schematic design workshop #7 & CPC review meeting summary

University of Oregon, Student Recreation Center

Workshop.....April 18-20, 2012
CPC Review Meeting.....April 30, 2012

Roof Monitor – Original Design

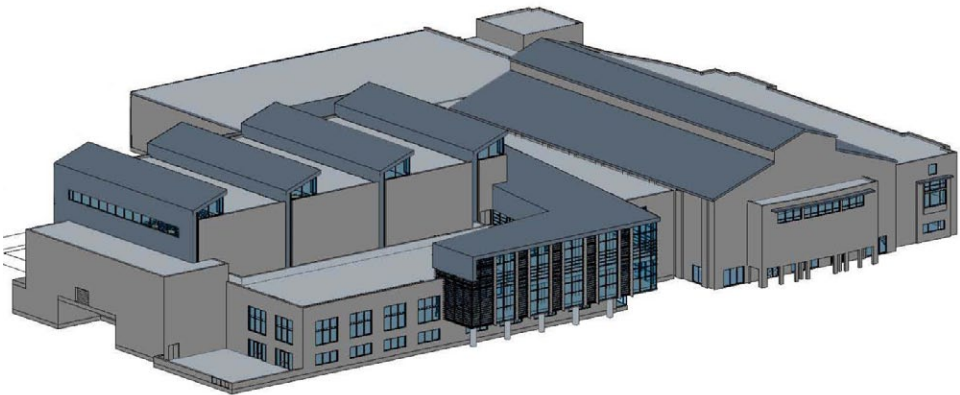
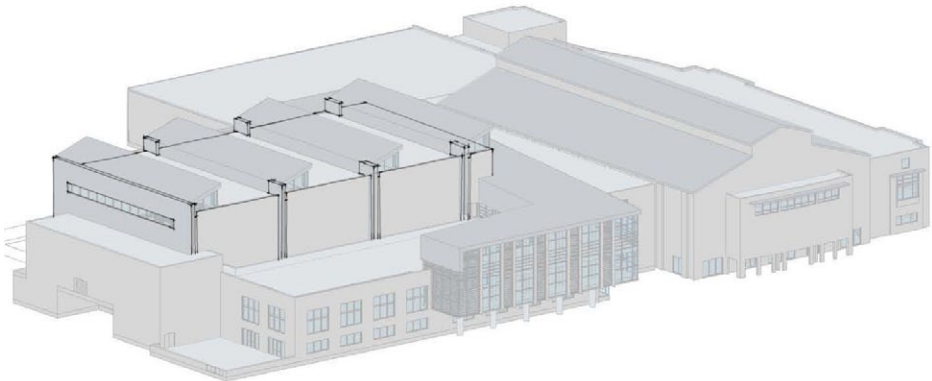
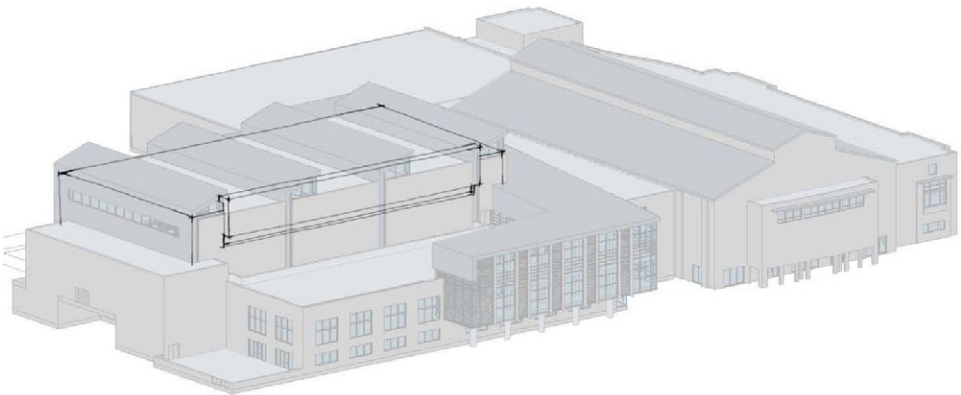
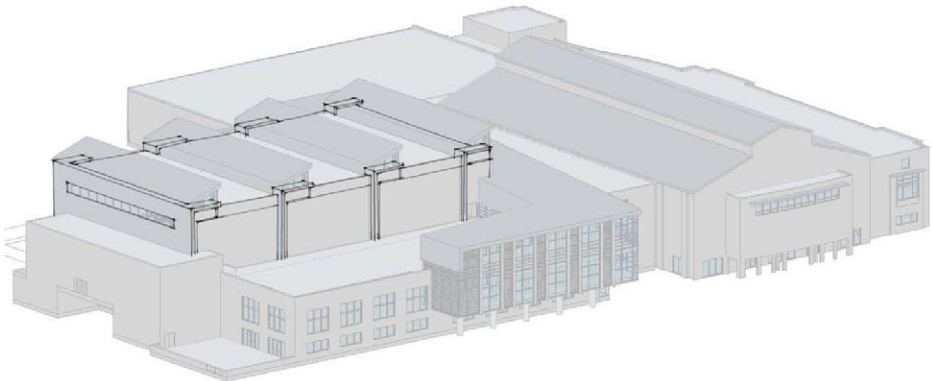
37. 9 - Eliminating roof monitors. Plan still maintains roof edge articulation, skylights and ventilation elements. Approved.
38. 10 – Reduce quantity of site. No

Roof Monitor – Option 4

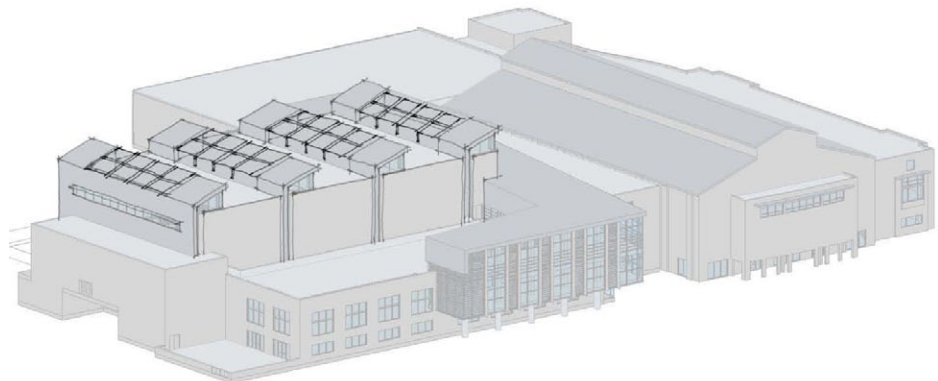
26. New fourth option for gym roof only removes about 2/3rds of center sections of sloped roof monitors and keeps east and west ends. Between these ends is framing for solar panels. Skylights and roof ventilators will be placed between the solar panels and centered over courts. Might be able to reuse existing outdoor tennis court glulam beams for spanning structural members. ESBL and Charlie Brown are working on day lighting studies. The group likes the new direction of the gym monitors.

- OPTION 4.
- DO WE GET ENOUGH LIGHTS FROM ROOF?
- VERIFY VENTILATION OPS.
- VERIFY NATURAL LIGHTING @ GYM.
- ARE THERE OTHER FLAT SKYLIGHTS @ UO? TBD
- USER GROUP SUPPORTS OPTION #4.

South Composition – Original Design

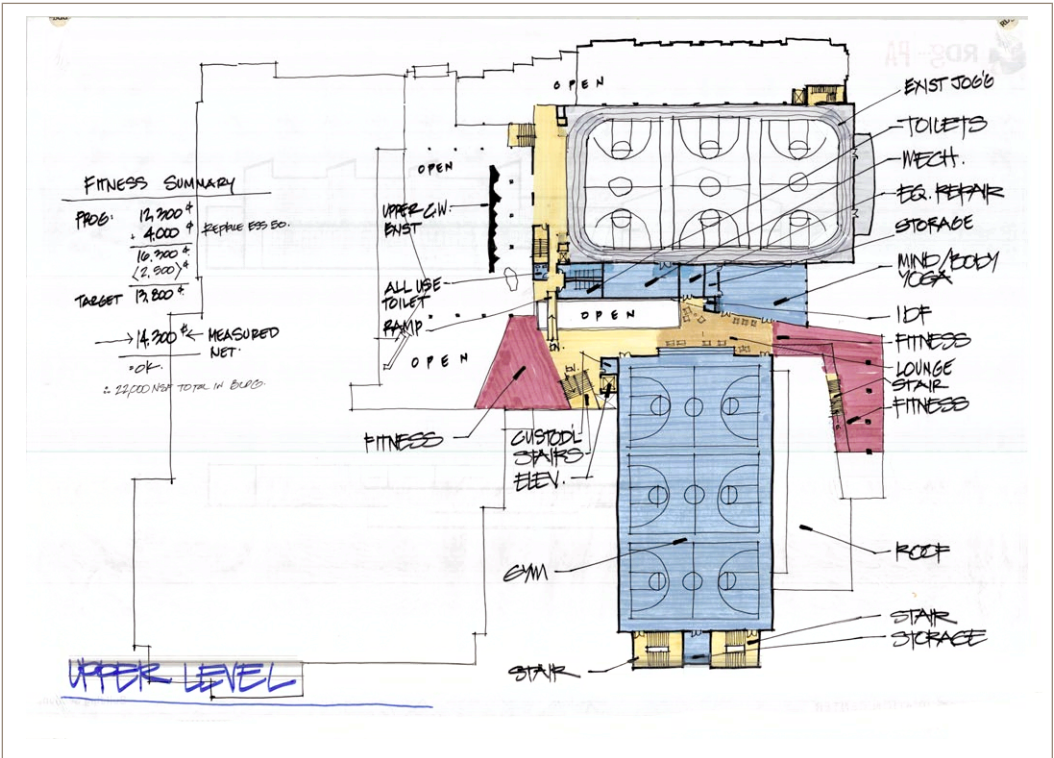
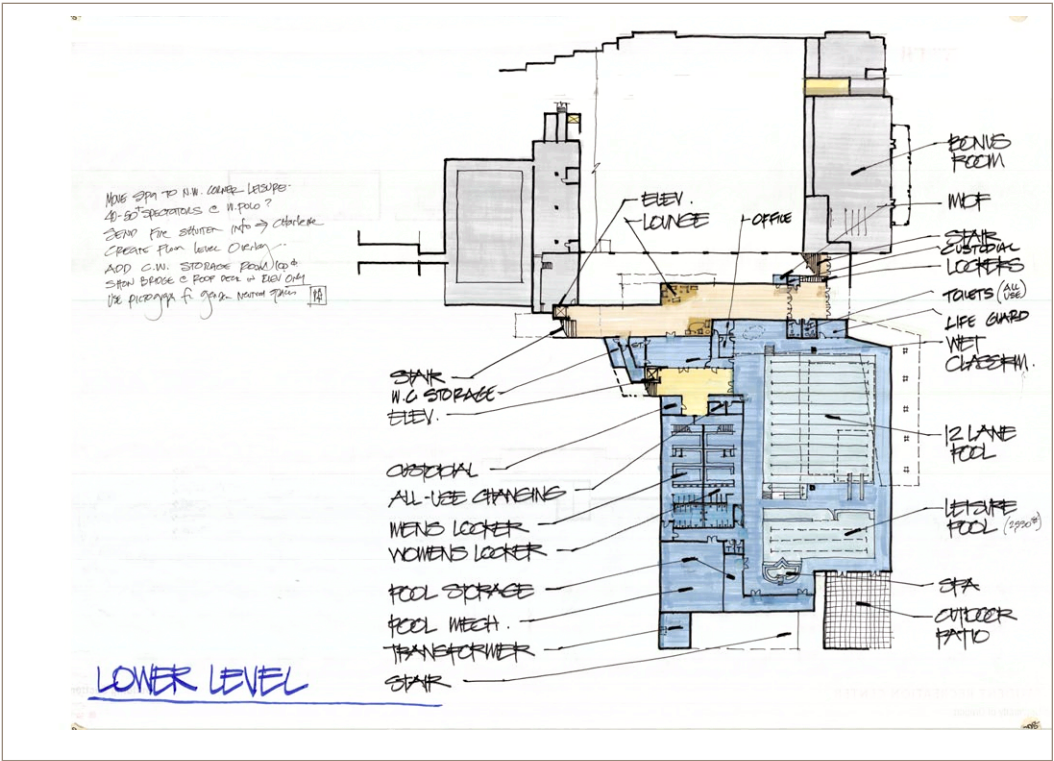
27. The south elevation was reviewed. It includes two enclosed stairs with ground level field storage and upper level gym storage in between. All are enclosed in brick cladding and the east and west edges are held in from main building mass. The tall height of the south gym wall will be broken up by the lesser mass of the stair. The stair walk surfaces are low cost prefab units that are utilitarian and only used during fire evacuation.

28. Group approves moving forward with south elevation, gym roof edge changes and site design for presentation to CPC

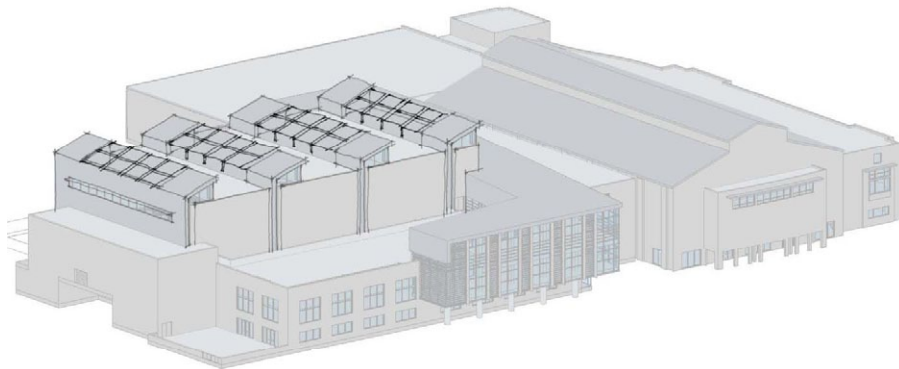
- Comment: Continue to work to make the east main entrance clearer and more defined. Possible solutions include further diminishing the depth of the recess, adding a projection beyond the building façade (this also would provide weather protection), adding landscape features at the pathway's intersection (e.g., lanterns reminiscent of the main SRC entrance), or adding a marquee.
- Entrance has been emphasized
- Has weather protection / canopy
- Ties to landscape features

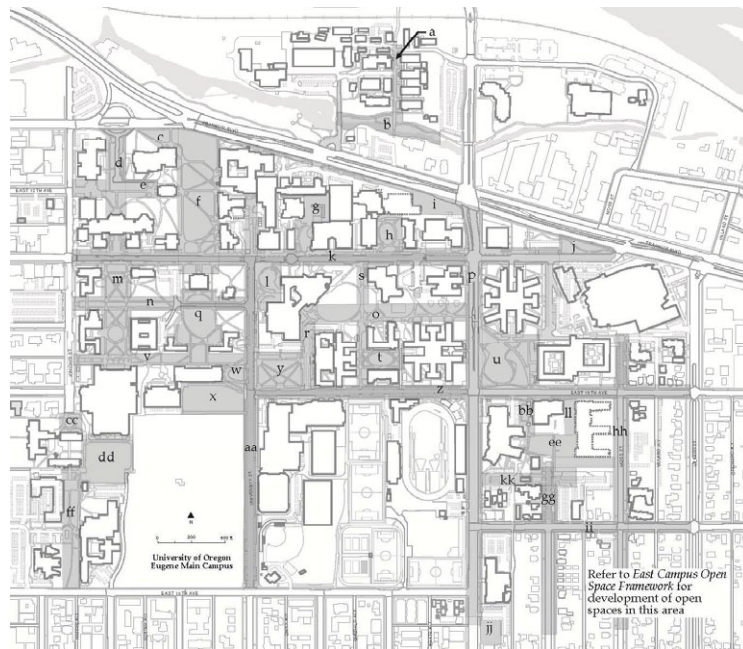
- Comment: If the project intends to propose a shift of some open-space enhancement funds to improve a non-designated open space (the north/south pathway), demonstrate how a majority of effort will go towards designated open-space improvements. If a small percentage of funds are used outside a designated open space, the proposal may be more acceptable. For example, enlarge the 15th Avenue improvement area to address the entire intersection and better link to the Emerald Axis.
- Based upon the size of our building addition (115,00sf), we need to provide improvements to Designated Open Space of approximately 18,400 sf (16%). We are proposing to improve 14,970 sf within the 15th Avenue and Emerald Axis Designated Open Space and 5,840 sf of improvements along the south portion of the bike/pedestrian path. Total improvements equal 20,810 sf.
